**ADDENDUM NO. 2**

**June 3, 2025**

**Taxiway A Reconstruction – Phase 6 and Midfield Ramp Repair – Phase 3**

**Duluth International Airport  
Duluth Airport Authority  
AIP No. 3-27-0024-080-2024  
SP No. A6901-220, A6901-222  
City of Duluth No. 25-4406  
SEH No. DULAI 179719 & 180793**

E-503

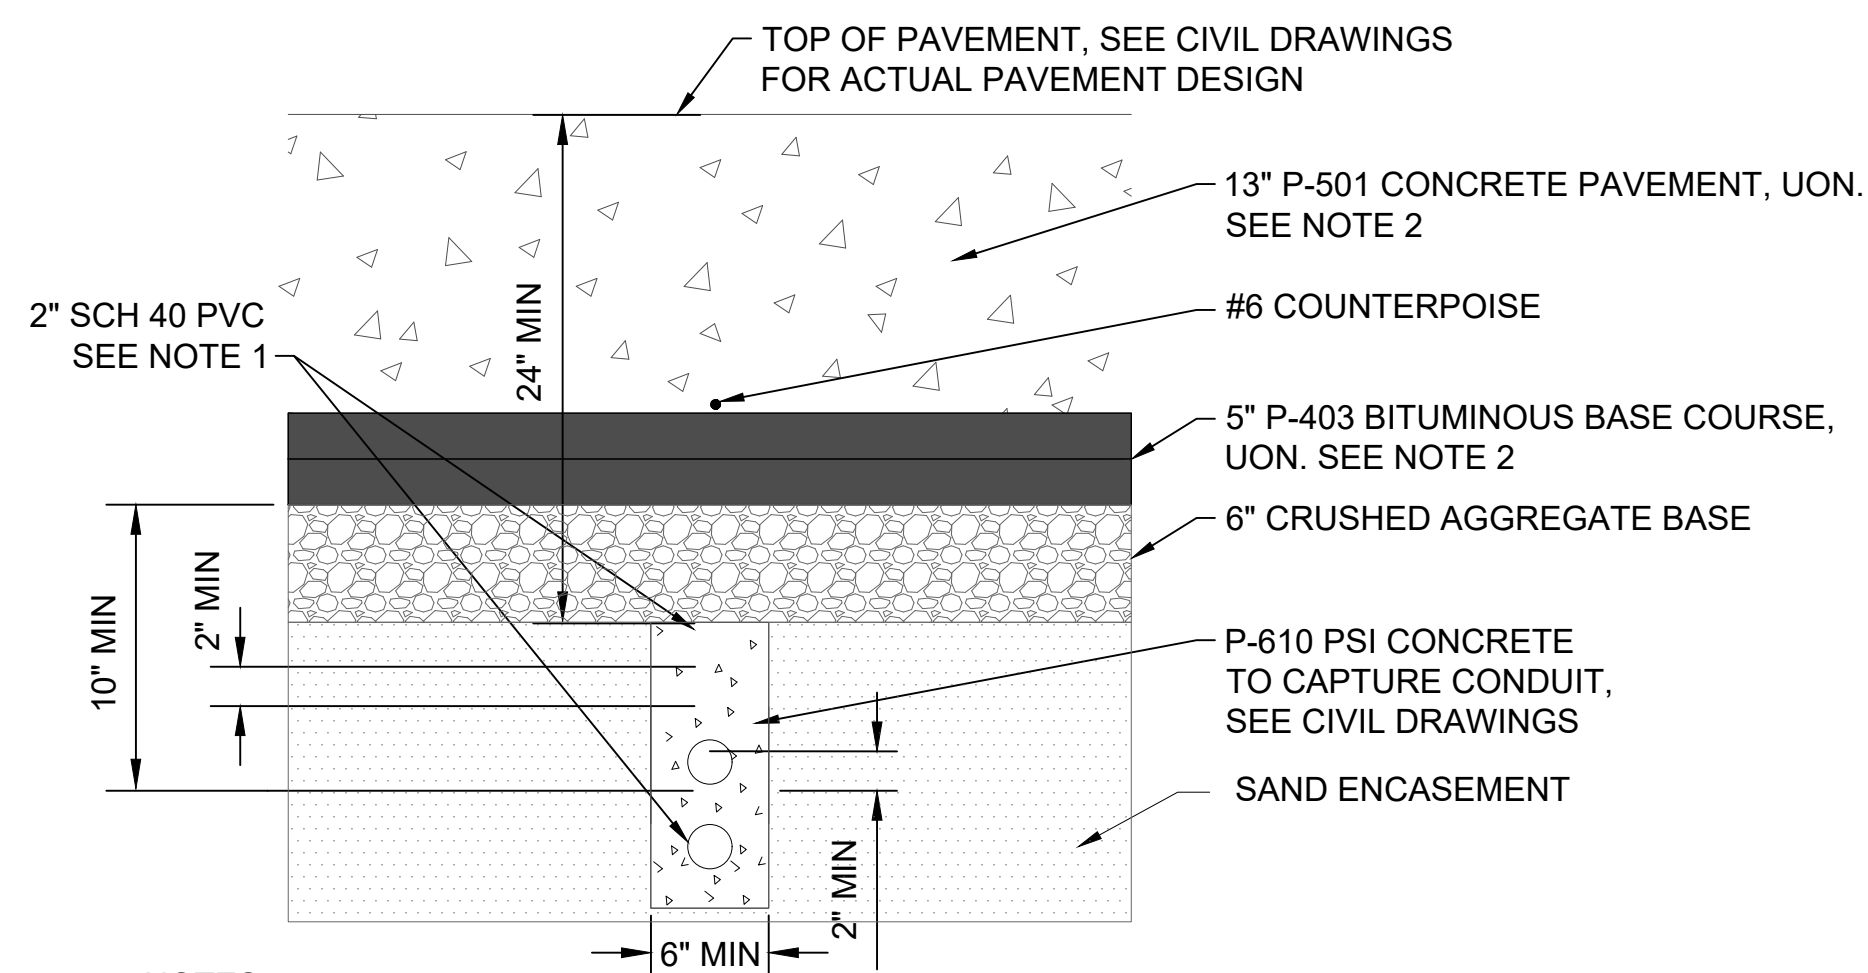
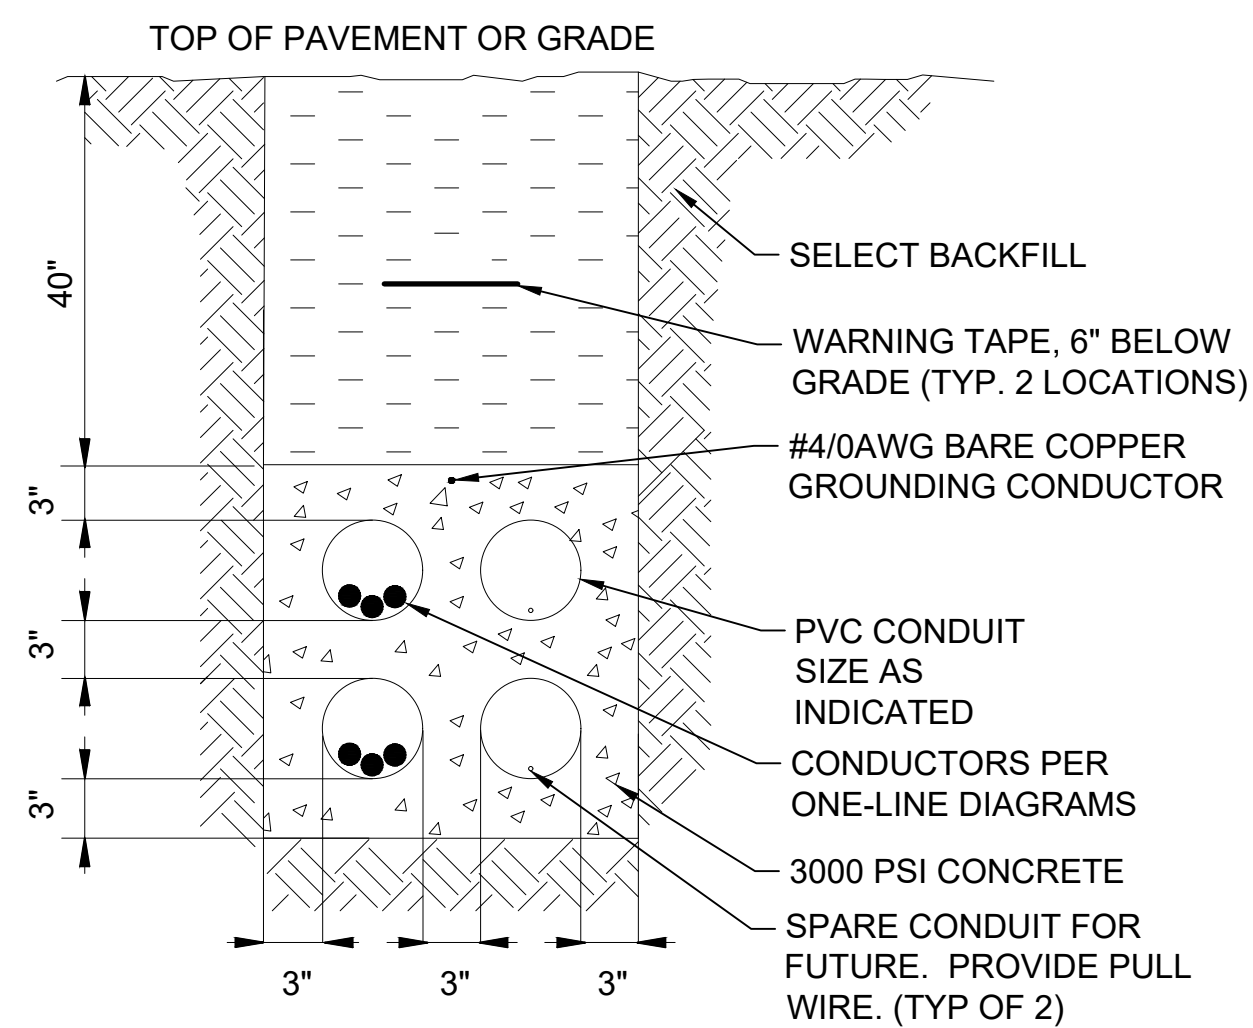
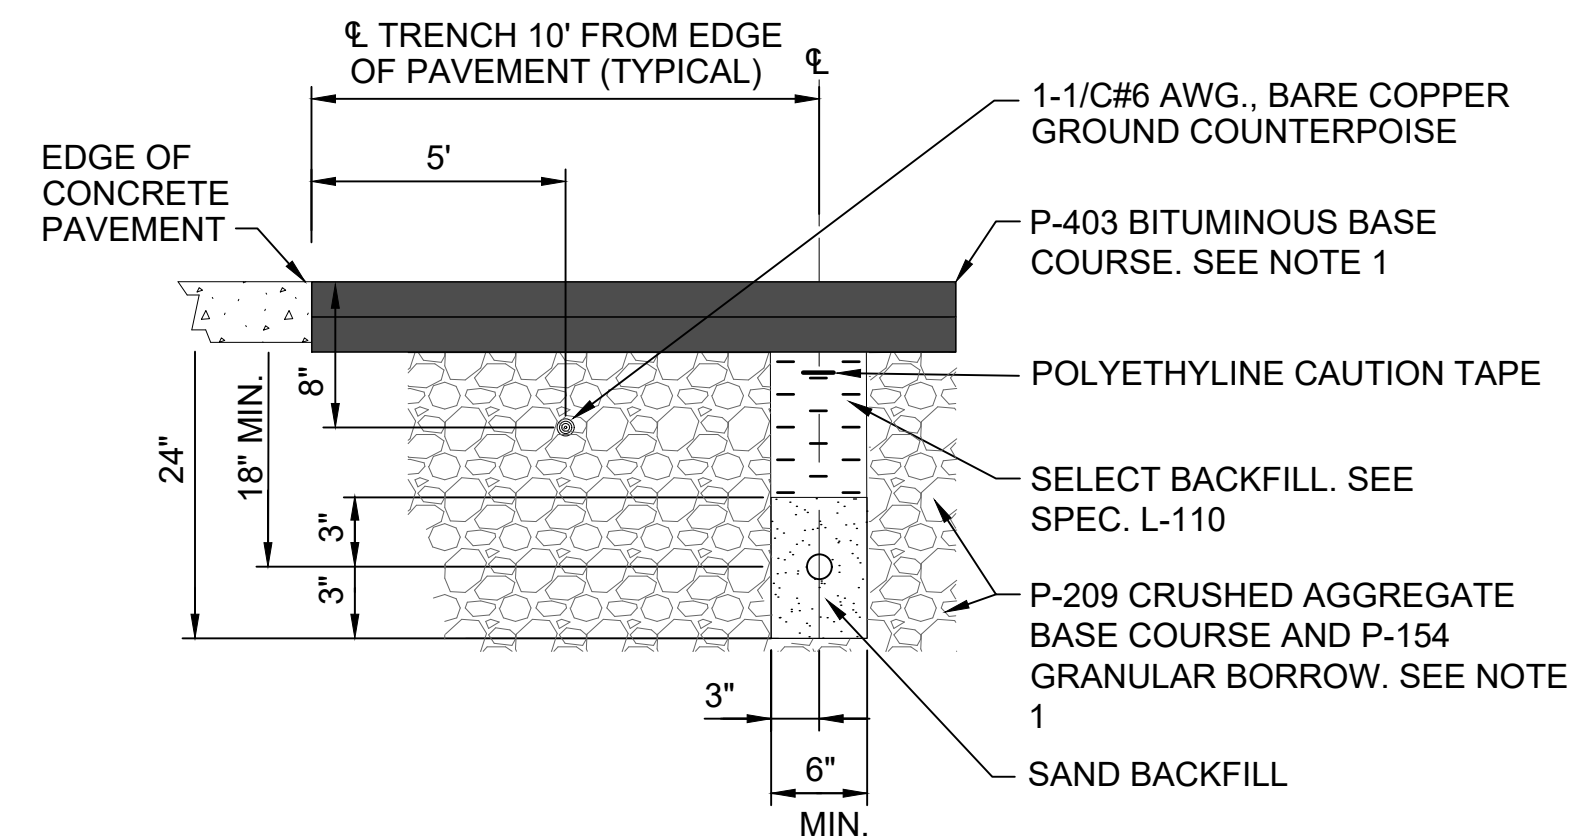
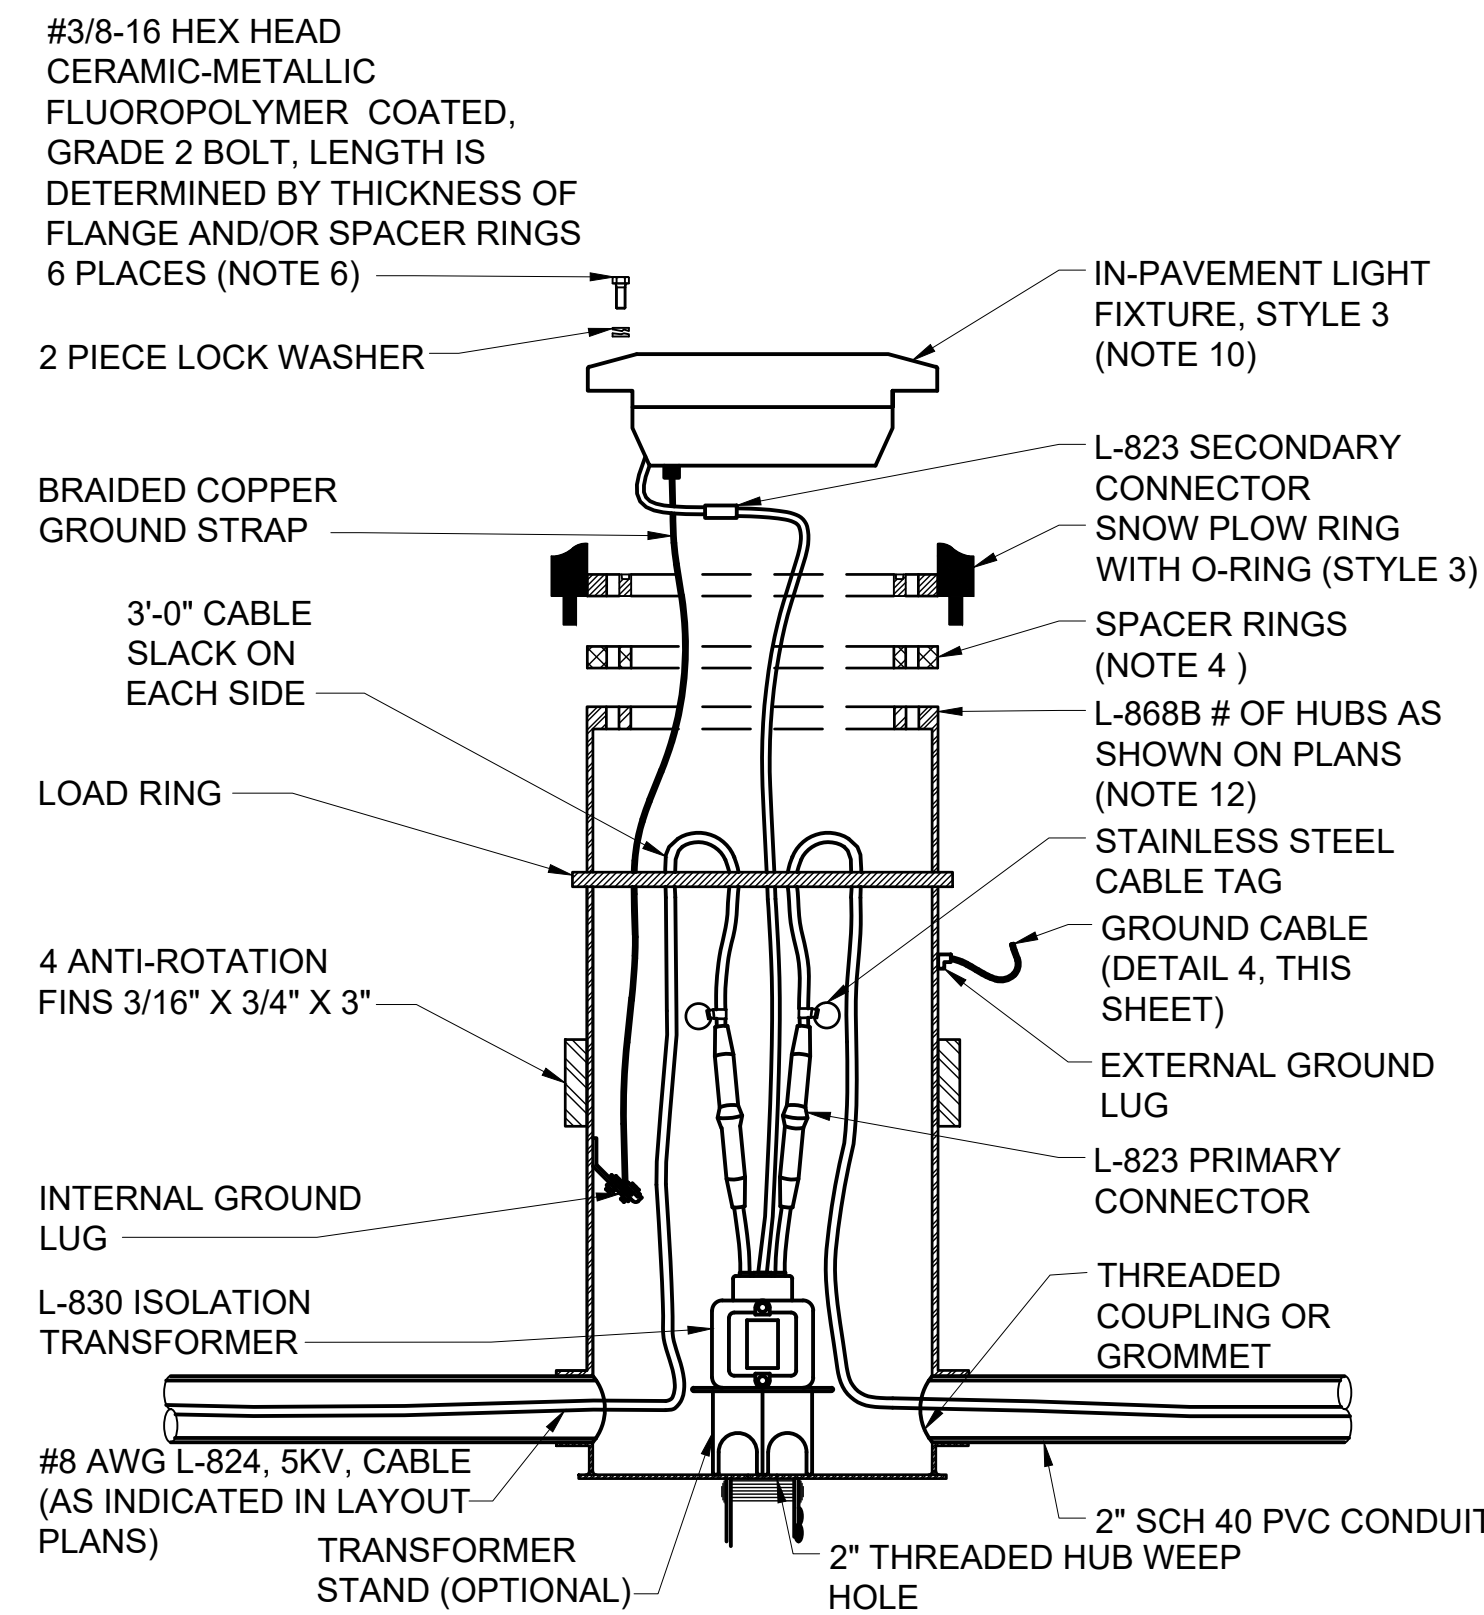
6. Plan Set A – Drawing E-503 Electrical Details 3: Remove Detail 5. DELETE in its entirety and REPLACE with the attached revised drawing.
7. Plan Set A – Drawing E-505 Electrical Details 5: Additional Sheet added to Plan Set A. INSERT in its entirety.
